Re: *WT Docket No. 20-443; GN Docket No. 17-183*

SpaceX Review of:

Assessment of Feasibility of Coexistence between NGSO FSS Earth Stations and 5G Operations in the 12.2 – 12.7 GHz Band, May 2021, RKF Engineering Solutions, LLC

Figure 2-7: Distribution of Starlink Terminal Elevation Angles at Ten Latitudes (as labeled) over CONUS

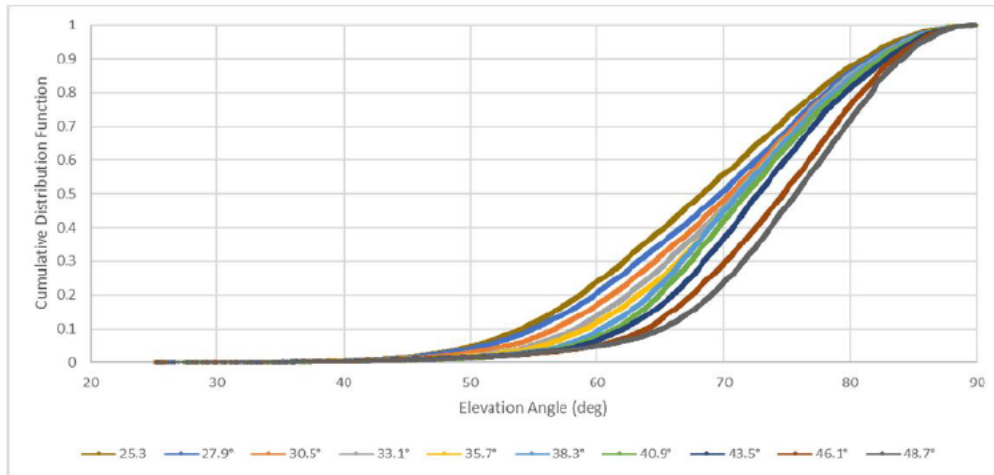
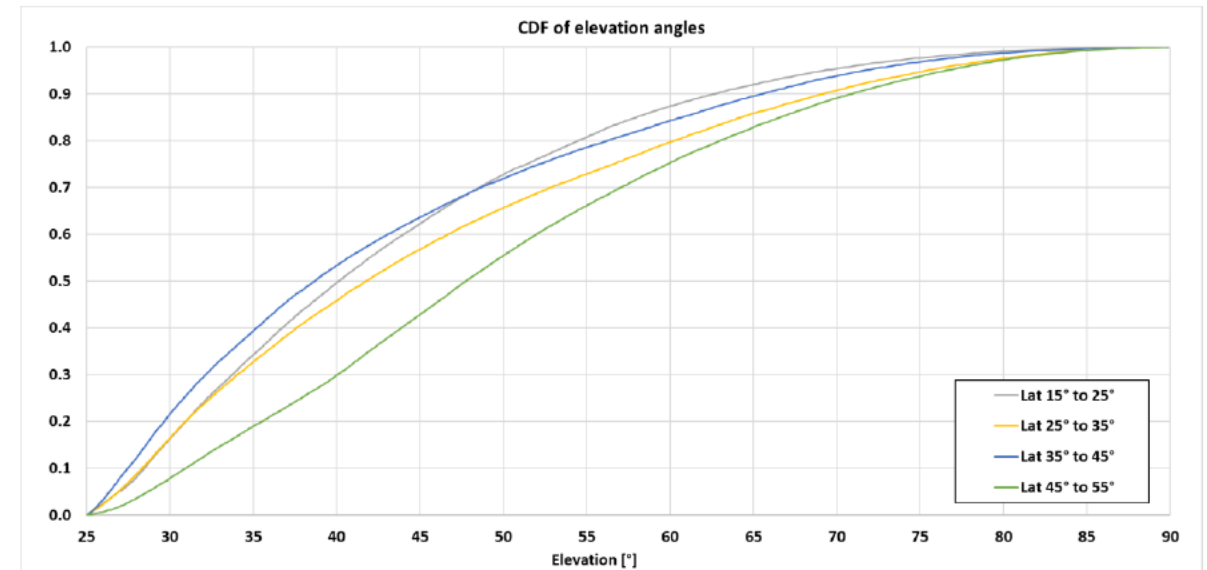
- Figure 2-7: Distribution of Starlink Terminal Elevation Angles at Ten Latitudes (as labeled) over CONUS
 - Completely false:

RKF Myth

Reality
